**Subject:** Revised Assessment Report “Revisions to ACM0008 to Include Methane Capture and Destruction from Abandoned Coal Mines”

## Revisions to ACM0008 to Include Methane Capture and Destruction from Abandoned Coal Mines

Report No.: 2009-9224

REVISION No. 02

Figure 1: Illustration of why AM0053 is needed to address projects using ACM0001

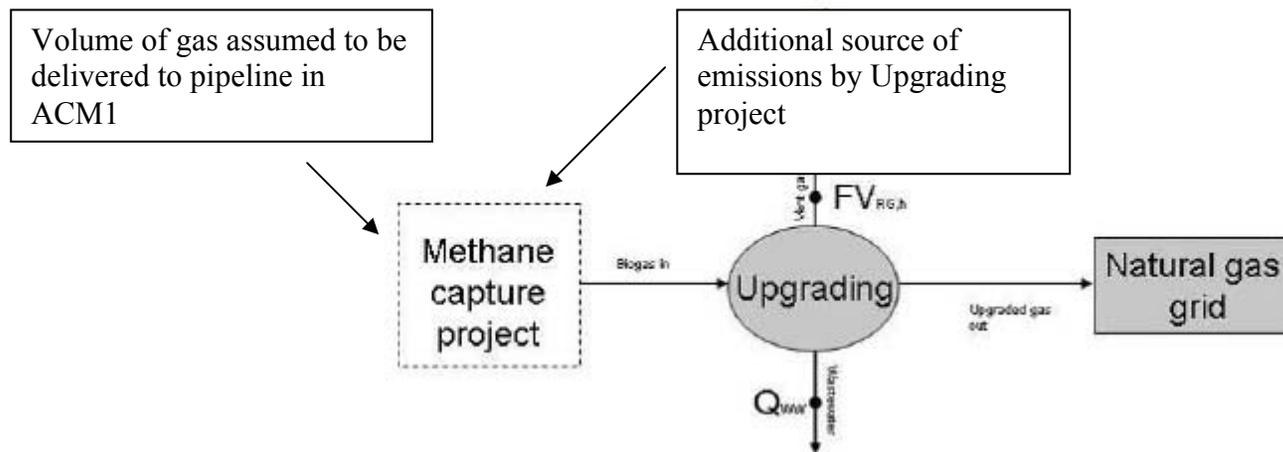
<b>Draft report clarifications and corrective action requests by assessment team</b>	<b>Summary of methodology developer response</b>	<b>Assessment team conclusion</b>
<p>2 The emission estimates related to the project activities of purification and handling of captured methane;</p> <p>3 The technology used for the purification and handling.</p>	<p>destruction of methane injected into gas grids in the baseline is quantified in equation 12. We have modified equation 26 by adding terms specific to methane use in gas grids for clarity. Additionally, we have added gas grid usage to the project’s baseline boundary in Table 1. We have added equation 33 which is similar to the existing equations (30-33) to calculate the combustion emissions from methane injected into gas grids. This seems to be missing from ACM0008 since methane from gas grids in the baseline displaced is an eligible source, but adequate guidance to calculate the emissions is not provided. The Appendix includes a detailed argument for why methane contained in processing equipment vent gases should be excluded.</p>

AM0053 addresses biogenic methane injected into natural gas distribution grids from LFG or AD projects. These projects draw their project boundary before the gas upgrading systems, thus “gas delivered to pipeline” is actually still LFG or biogas containing CO<sub>2</sub> and is not delivered upgraded “natural gas”. Presumably, this is because the LFG project and the gas upgrading project are typically developed by separate project proponents (e.g. LFG developer and gas distribution company). For the gas upgrading project, emissions from venting of CH<sub>4</sub> need to be accounted for since they are not accounted for in the LFG project. In the revised ACM0008, we account for venting by using the “gas injected” quantity rather than “gas to pipe feeding natural gas grid” quantity.
